APPLICATION FOR ZONING RELIEF AND CERTIFICATE OF APPROPRIATENESS HISTORIC CONSERVATION BOARD PUBLIC HEARING STAFF REPORT

APPLICATION #: ZH20190115/ COA2019041
APPLICANT: Evans Engineering – Jonathan Evans
OWNER: Pencil Dart LLC
ADDRESS: **1920-1922 Dunlap Street**
PARCEL: 096-0005-0104; 096-0005-0105; 096-0005-0106
ZONING: UM
OVERLAYS: Over the Rhine Historic District
COMMUNITY: Over the Rhine
REPORT DATE: July 8, 2019
HEARING DATE: August 5, 2019
STAFF REVIEW: Douglas Owen, Zoning Plan Examiner

APPLICATION FOR CERTIFICATE OF APPROPRIATENESS HISTORIC CONSERVATION BOARD PUBLIC HEARING STAFF REPORT

APPLICATION FOR CERTIFICATE OF APPROPRIATENESS HISTORIC CONSERVATION BOARD PUBLIC HEARING STAFF REPORT

PARKING LOT - DUNLAP ST.
TITLE SHEET & GENERAL NOTES
 1920 & 1922 DUNLAP ST.,
 CINCINNATI, HAMILTON COUNTY, OHIO

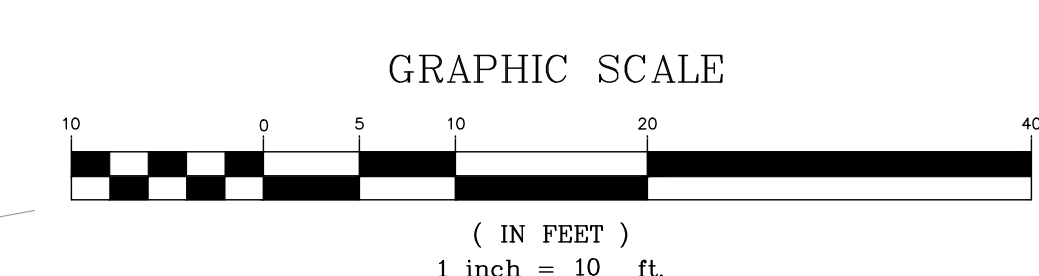
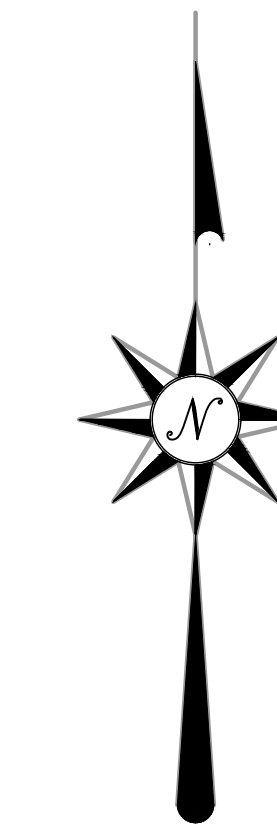
The parking lot is screened from the public streets with a 3.5-foot planting area to the north of the curb cut and a 11-foot landscape buffer to the south of the curb cut which will contain the two required tree plantings per the Zoning Code. While no additional landscaping is currently proposed, Staff recommends landscaping above simple grass cover to the north of the curb cut along the Dunlap frontage that will grow to a minimum of 3 feet in height to screen the lower portion of the vehicles. This would allow for a significant screen and buffer while still providing views into the parking lot for safety. The lot will be surrounded on three sides by a black metal fence. While the surfacing material is proposed as asphalt, Staff would encourage pavers or scored concrete to break up the solid surface, if the project budget allows.

- c. The frontage fencing shall incorporate columns and fence heights in keeping with those installed south of the project. Landscaping growing at least 3' in height shall be planted along the Dunlap St. frontage to provide more effective screening along the right of way. Planting types and minimum 5 gal. sizes shall be specified on the building permit.

- d. All electrical service to and upon the site shall be underground.
 - e. Pavers or scored/ patterned concrete shall be used as surfacing material on the 11 ft. of entry drive entrance behind the right of way.

Figure 3. 1891 Sanborn Fire Insurance Map with subject property outlined in red showing original two-story addition at rear.

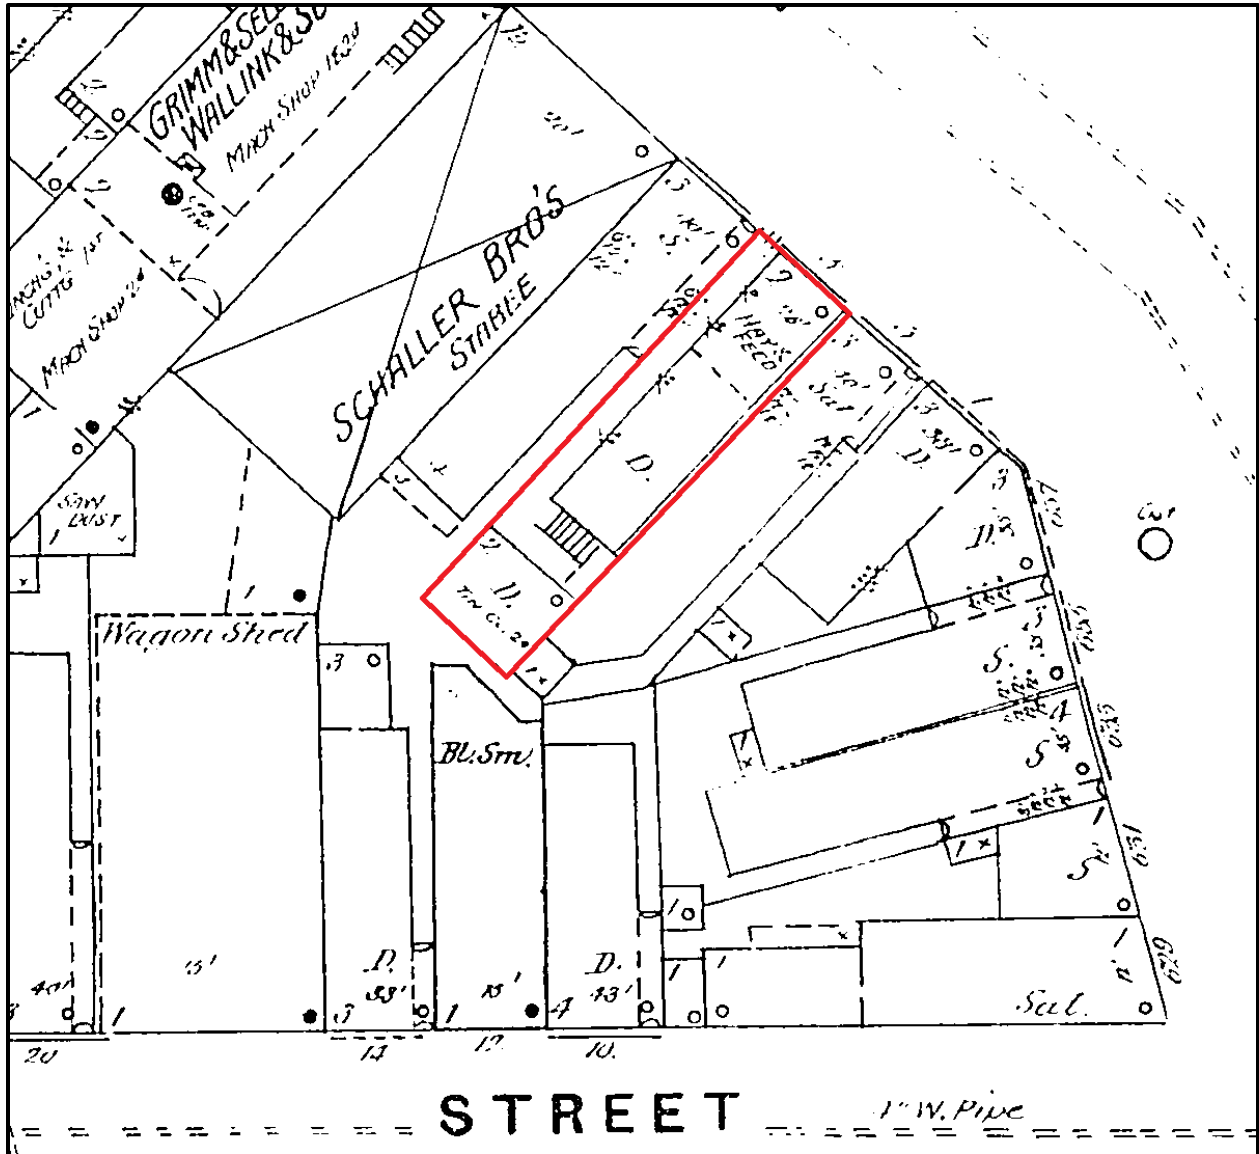
The rear addition was a historic structure as it appears in the 1891 Sanborn map. However, the structure was severely deteriorated with evidence of termite, fire and water damage. The addition was originally built crossing a parcel boundary on the west with floor joists sitting directly on the ground causing many of the problems that led to its deterioration. The addition was formerly clad in wood lap siding on two sides with corrugated metal sheets installed as siding on the rear.

ELEVATION A-1 SCALE: 1/4" = 1'-0"
 ELEVATION B-1 SCALE: 1/4" = 1'-0"
 ELEVATION C-1 SCALE: 1/4" = 1'-0"

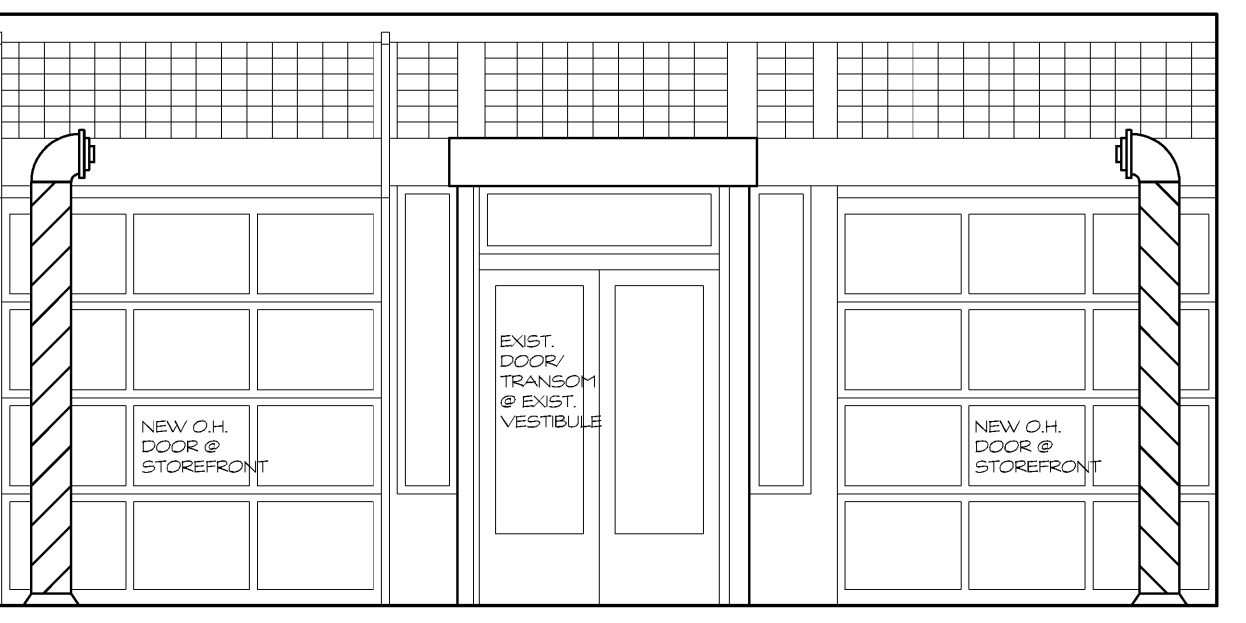
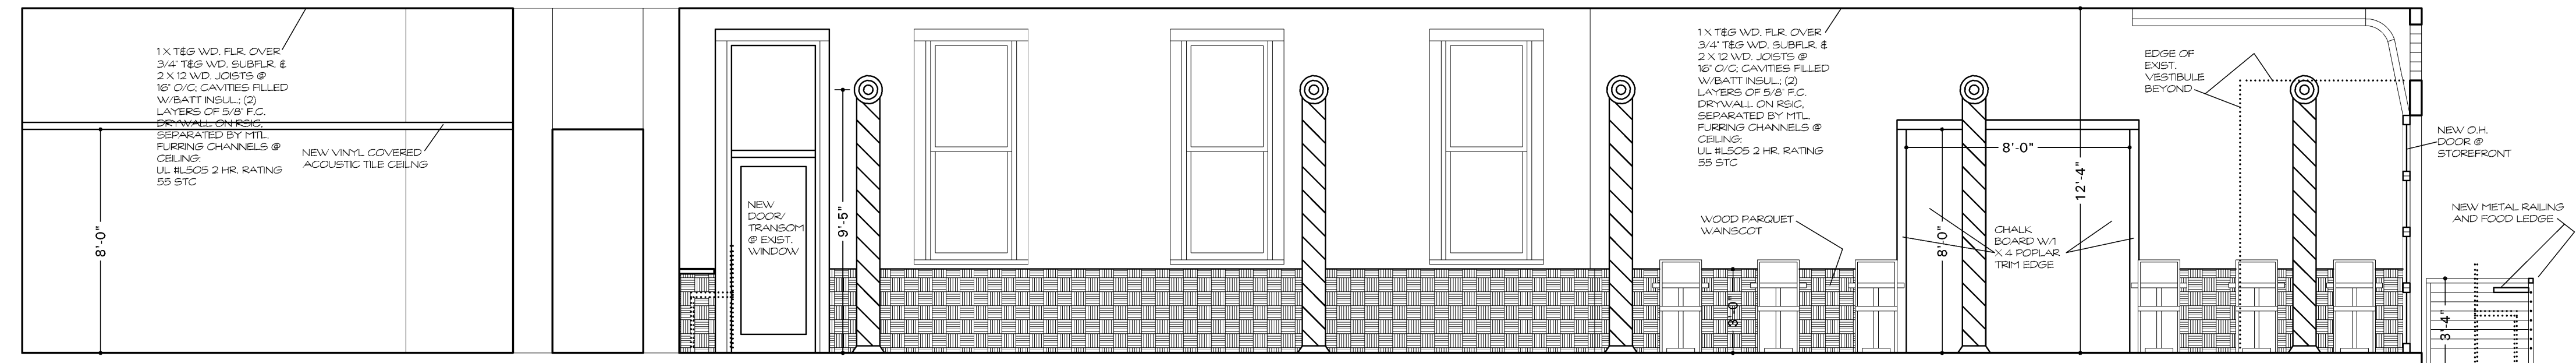
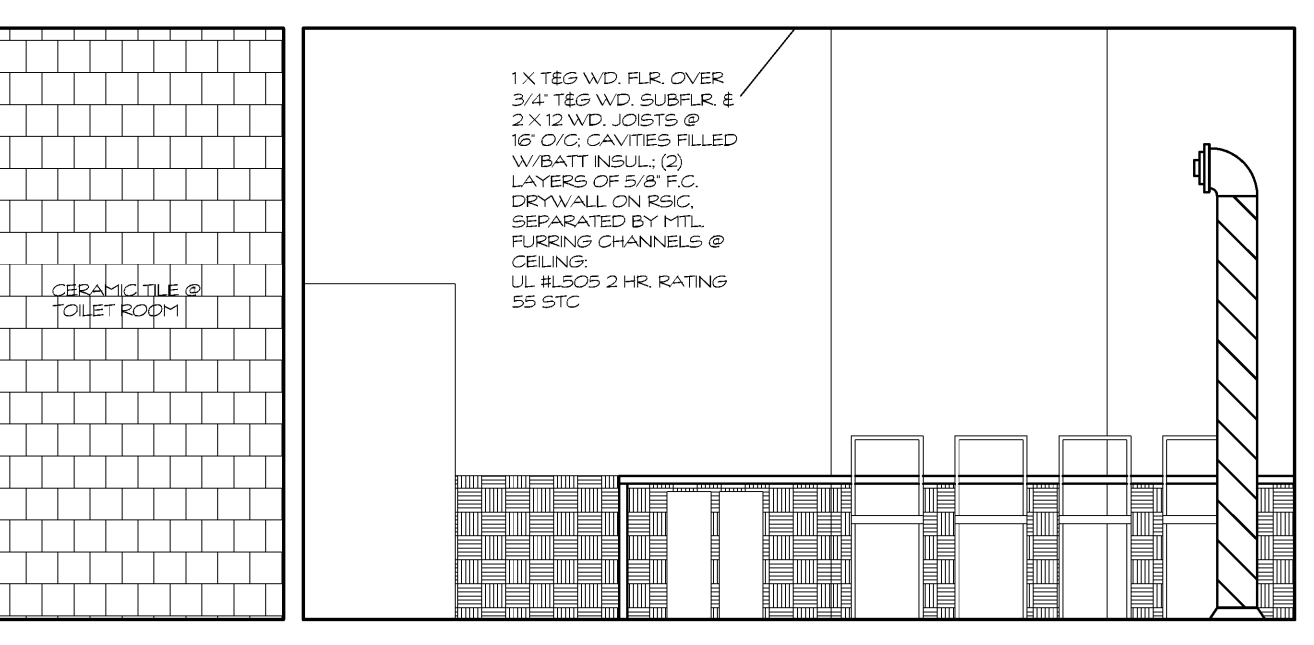
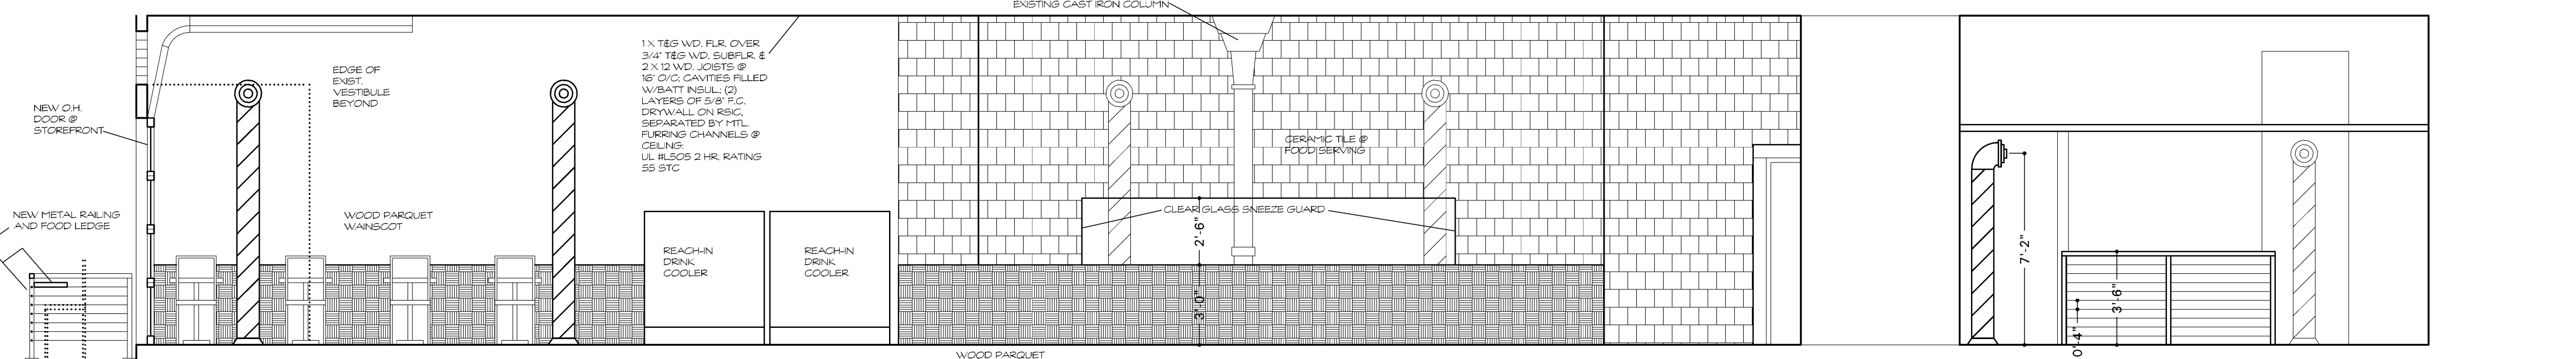
While staff appreciates that the applicant is retaining both an impression of a knee wall, and all original storefront context, we believe the folding door solution is more appropriate and contextual, particularly on such a high profile, highly visible and highly ornate structures as this one at the entrance to the neighborhood. If the applicant or Board are disinclined to amend to bi-fold panels, Staff has in the previous applications, taken particular care in specifically selecting a garage door with the most minimal framework necessary, both to expand the glass and reduce the visibility of the frame, and lessening the horizontal character of the door.

Staff continues to have concerns over the strong horizontal members of the garage doors and would strongly discourage them in lieu of bi-fold doors. The fact that this treatment is reversible, and all original fabric is being maintained staff finds acceptable and contributing to permitting the openable storefront to be considered.

1. **APPROVE** a Certificate of Appropriateness 1107 Vine Street per plans submitted by Wichman Gunter Architects dated 6/19/2019 with the following conditions:
 - a. Staff encourages the applicant to consider and the Board approve the use of a bi-fold door system and this change would be approved at a staff level.
 - b. If garage doors are approved by the Board, applicant shall demonstrate to staff that the door to be approved has mullions that are as thin as possible.
 - c. The building permits must be issued within two years of the decision date or the Certificate of Appropriateness shall expire.
